COMMISSION MEETING DATE:	04/15/2020
NAME & NUMBER OF PROJECT:	Albert H. Ullrich Water Treatment Plant SPC-03-0005C(R1)
NAME OF APPLICANT OR ORGANIZATION:	MWM Design Group; Shari Pape
LOCATION:	3602½ Redbud Trail Unit C, 78746
COUNCIL DISTRICT:	District 8
ENVIRONMENTAL REVIEW STAFF:	Scott Hiers, Environmental Scientist Senior, Watershed Protection Department, 512.974.1916, scott.hiers@austintexas.gov Pamela Abee-Taulli, Environmental Review Specialist Senior, Development Services Department, 512.974.1879, pamela.abee-taulli@austintexas.gov
WATERSHED:	Bee Creek, Little Bee Creek, & Lake Austin watersheds, Water Supply Rural Classification, Drinking Water Protection Zone
REQUEST:	Variance request is as follows: Request to vary from LDC 25-8-281(C)(2)(b) to allow the construction within 150-foot Critical Environmental Feature (CEF) buffer for a Rimrock CEF.
STAFF RECOMMENDATION:	Staff recommends this variance, having determined the findings of fact to have been met.

Project Name &
Case Number: **Albert H. Ullrich Water Treatment Plant - SPC-03-0005C(R1)**

Variance Request: **To allow construction within 150-foot Critical Environmental Feature (CEF) buffer for a Rimrock CEF [LDC 25-8-

C-01A
SHEET
7A OF 39

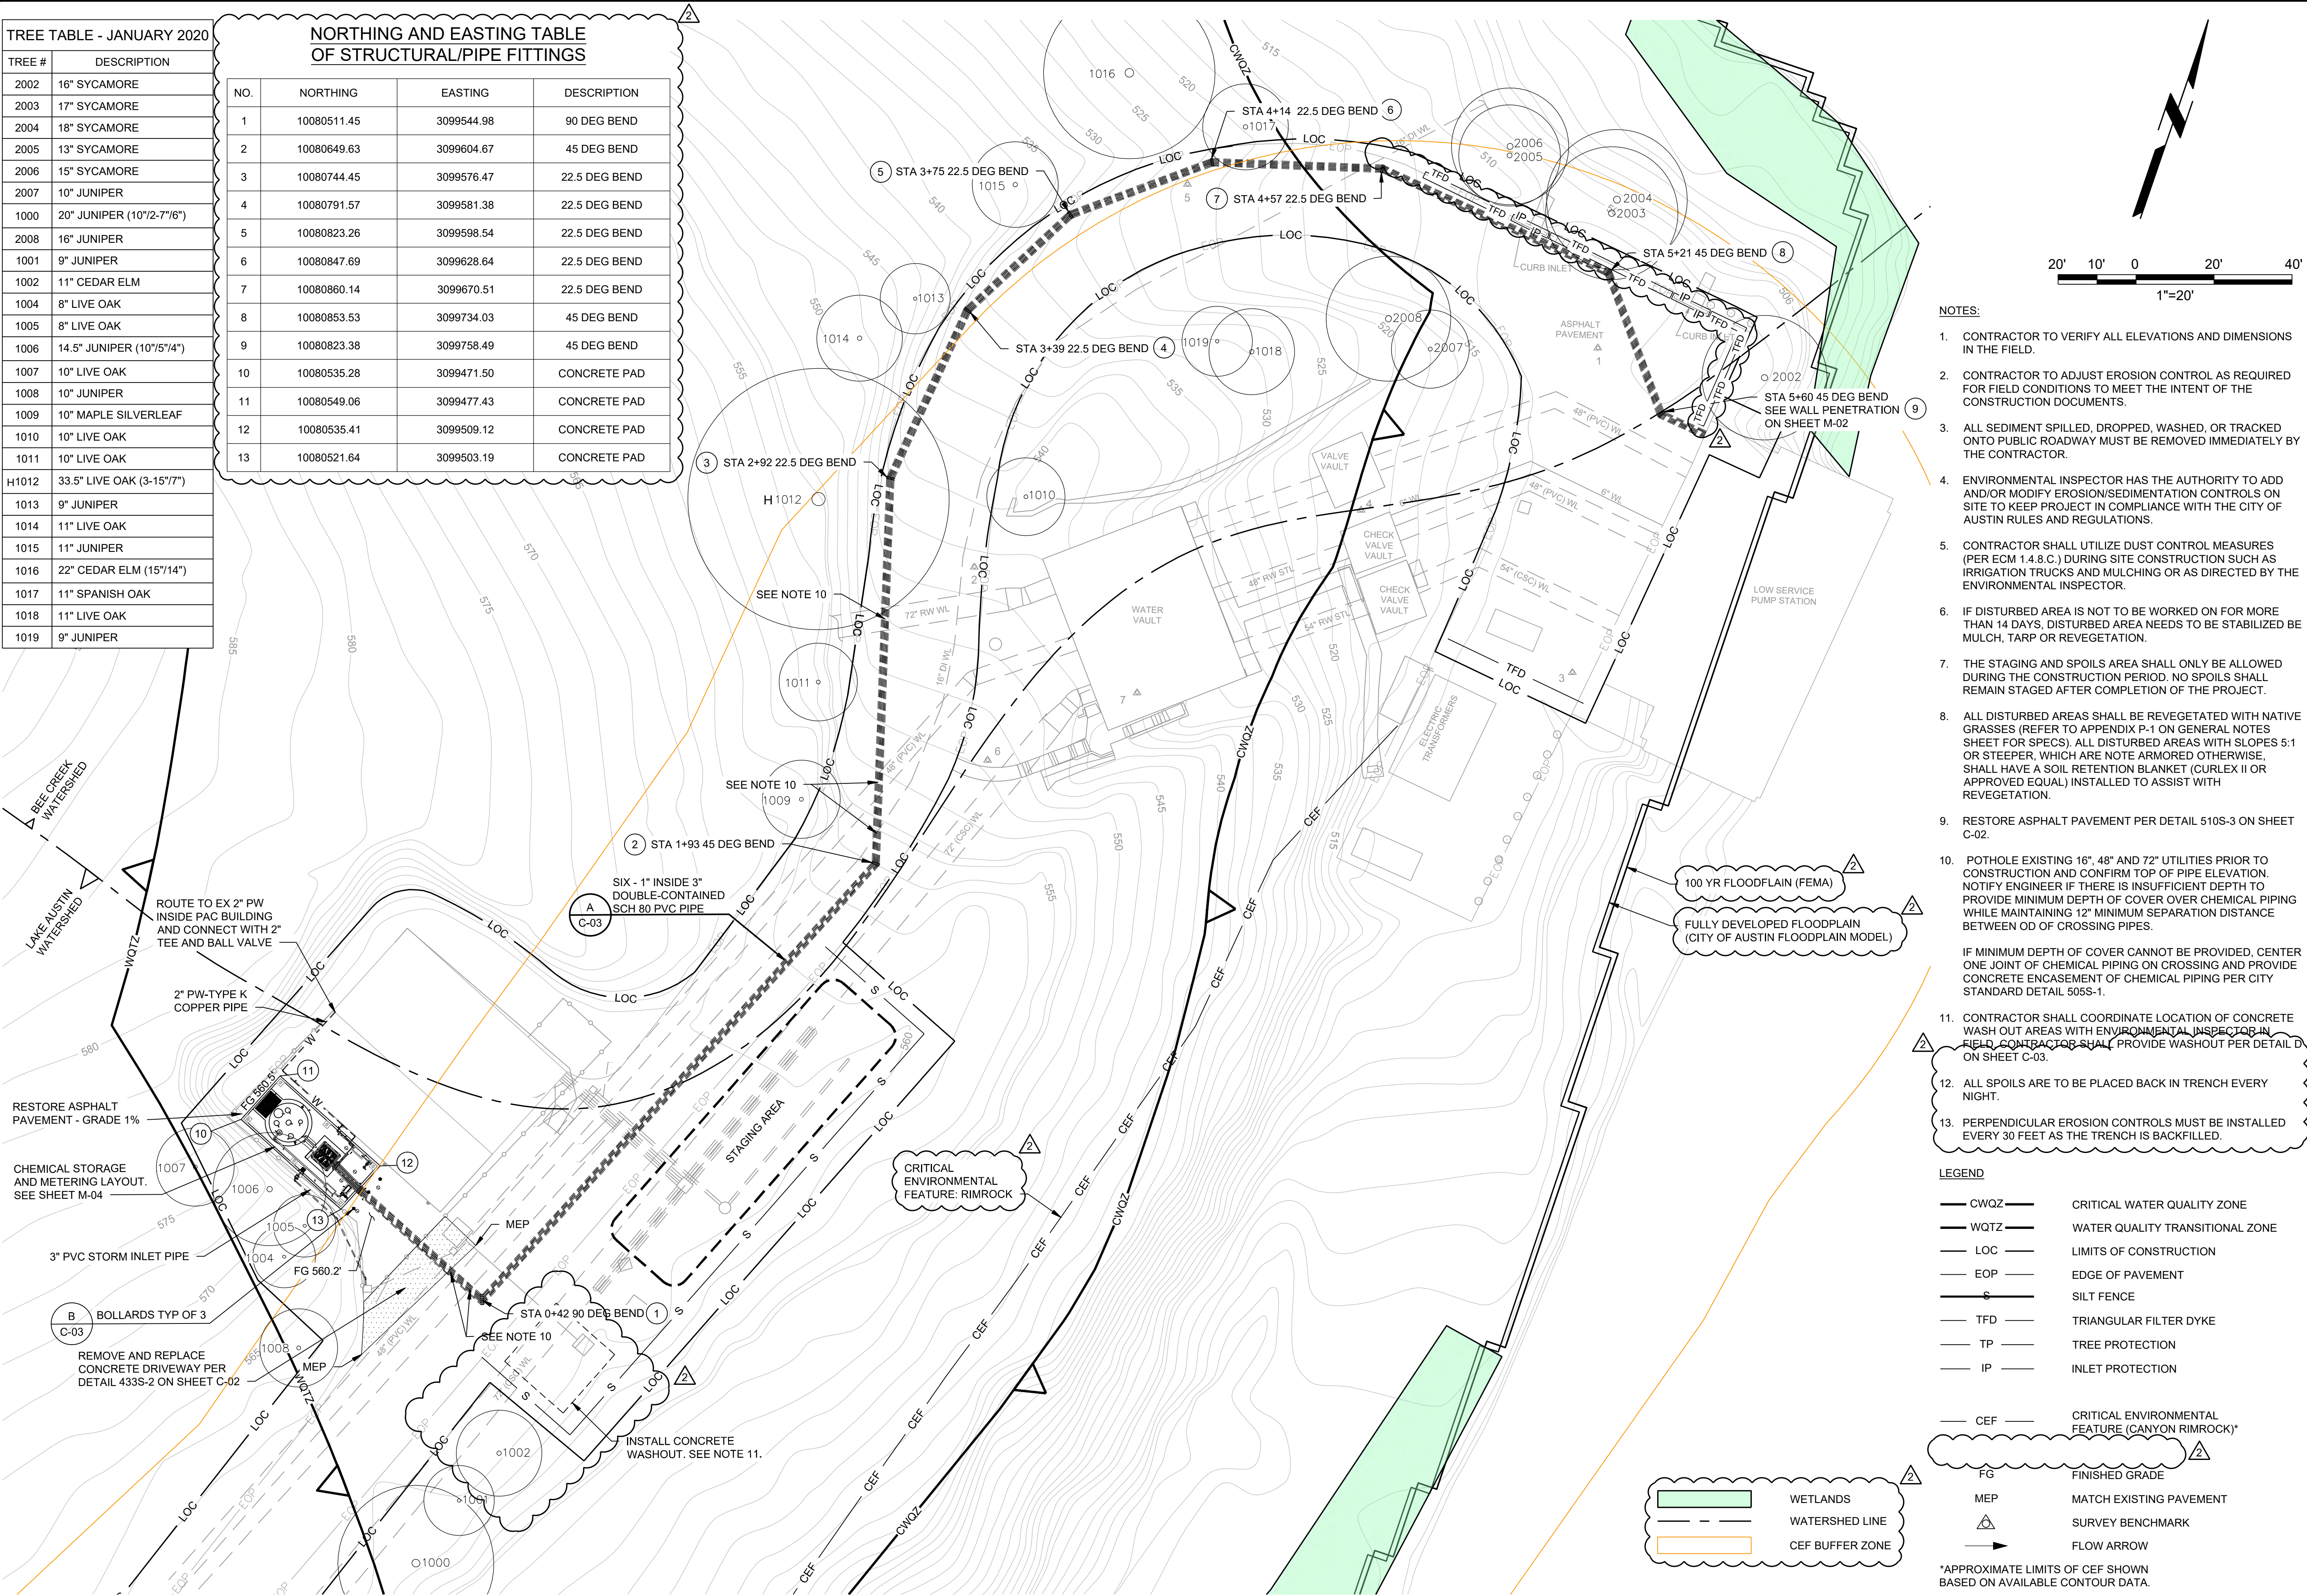
Clearly indicate in what way the proposed project does not comply with current Code (include maps and exhibits)	• Construction will be performed within the 150' rimrock CEF buffer and within 150' wetlands CEF buffer.

Yes The chemical storage and metering station was situated where there is already an asphalt driveway, which means the station will require no new impervious area. The chemical piping was routed in the shortest and most direct route and does not disturb any vegetated areas.
